DA201300375 - 6-26 Grove Street, Dulwich Hill

We are writing in response to Council's letter of 19th December 2013 (Attachment A) that identified a number of matters for review and consideration.

Figure 1 Rail Corridor – Winter Solstice 11.30am

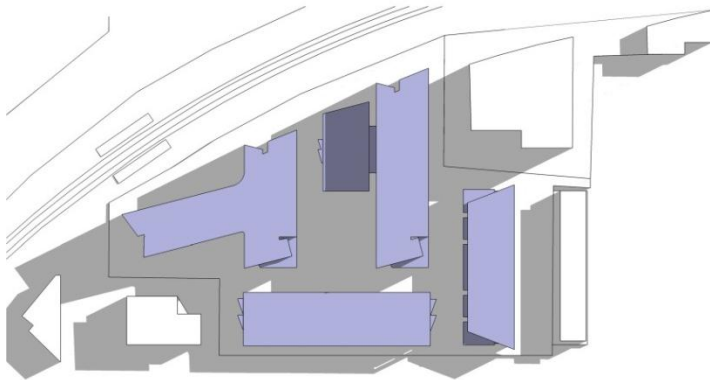
The DCP requirement is for common landscaped area to receive a minimum of 2 hours of direct sunlight over 50% of its finished surface between the hours 9am & 3pm in mid-winter. This is achieved to the landscaped area adjacent the rail corridor, which is more than 50% of this area and therefore the scheme complies with the DCP, as shown in the diagrams below.

Figure 3 - Central Grove – Equinox 12:45pm

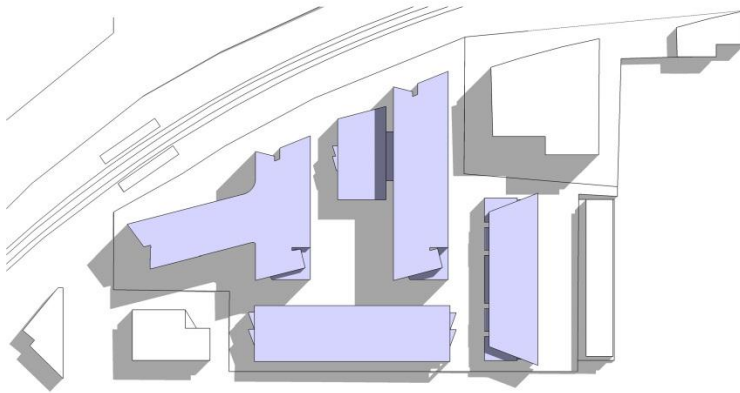
The central open space achieves more than 2 hours of direct sunlight over 50% of its finished surface from the Spring Equinox through summer to the Autumn Equinox, as shown in the diagrams on the following page.

Figure 6 – Propsoed Envelope Plan for entire precinct

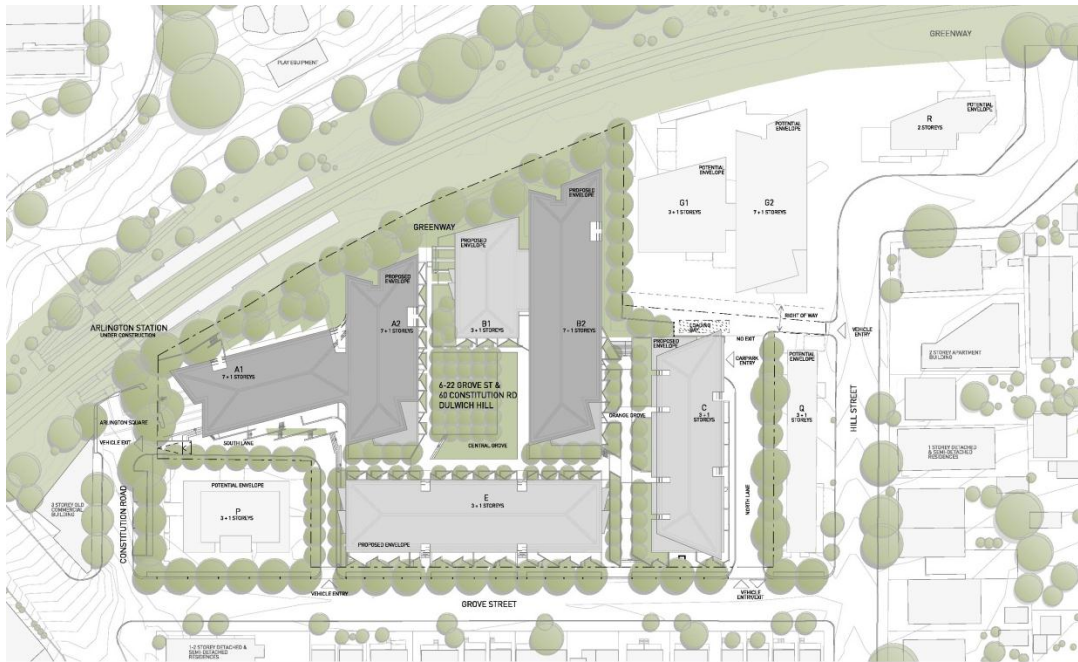
As a result of studying the neighbouring site, Smart Design Studio concluded that the best design outcome would entail a taller building situated to catch the north sun with appropriate setbacks to the street combined with a lower, wider wing oriented towards green spaces flanking the neighbouring site.

This solution is shown in **Figure 6** below, as the recommended envelope for the neighbouring site, in the previously submitted Envelope Plan.

The concept in **Figure 6** has the following advantages:

- Maximises apartments achieving 3 hours solar access in winter.
- Maximises apartments with views over the park.
- Minimises south facing apartments.
- Provides a reasonable landscaped space.
- Creates a clear and strong identity for the building which addresses the street and clearly defines the surrounding open spaces.
- Reduces overshadowing to the surrounding buildings.
- Can be designed with no acoustic/privacy impacts on surrounding buildings.

Figure 7 - Recommended arrangement of neighbouring site (G)

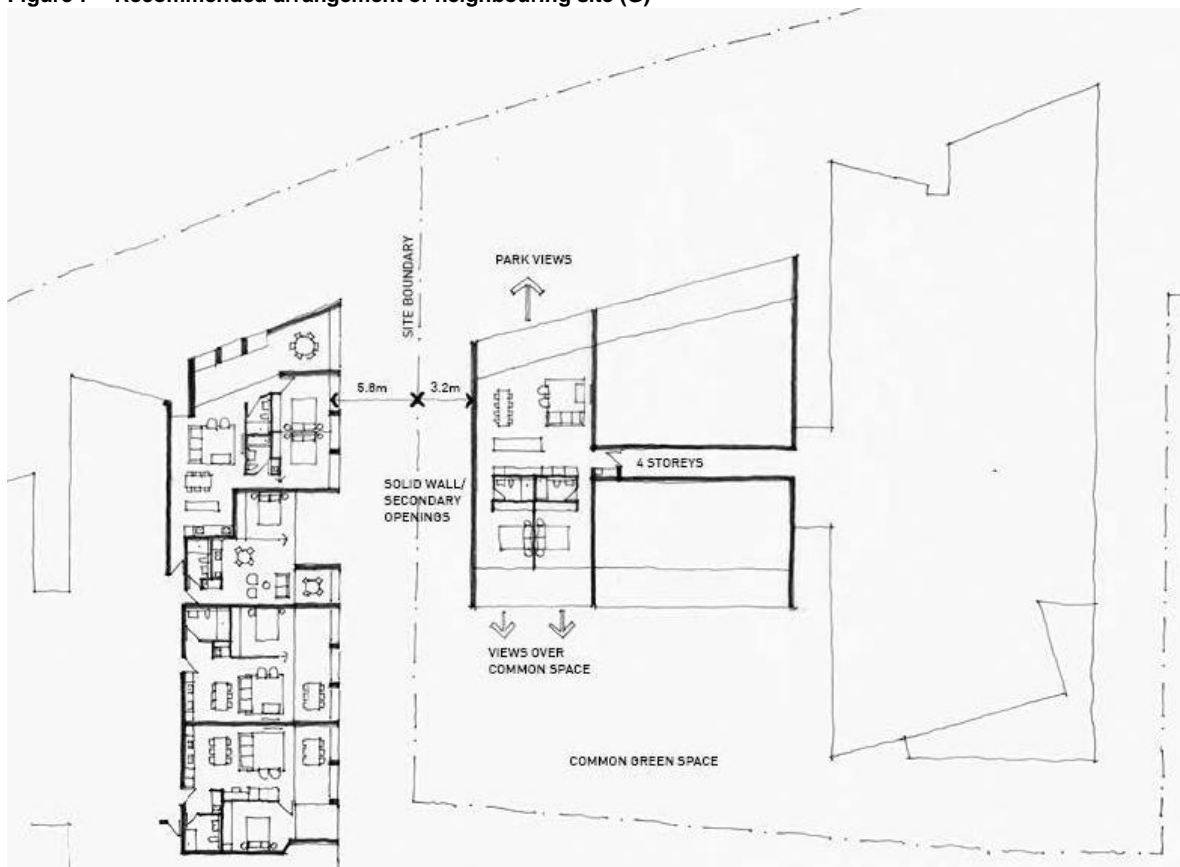
That being the case, Smart Design Studio has prepared a recommended building separation arrangement (in **Figure 7**) that addresses the future building envelope for Stage G as well as building separation from Building B2.

With the setback from habitable windows/balconies from the proposal to the north-west boundary being approximately 6 metres a four storey building element located on the neighbouring site could have a setback to this boundary of 3 metres. This arrangement increases the opportunities for designers to accommodate available floor space in different ways from the DCP 2011 envelope. An example floor plan (shown in Figure 2) of such a four storey element indicates that the southernmost apartment is best oriented to have habitable rooms facing west and east, with a blank façade or secondary windows to the south.

SDS' review of the neighbouring site (G) suggests that the recommended envelope is the best solution for this site and that it is capable of being developed with the approximately 6m setback currently proposed for the subject site along the north-west boundary.
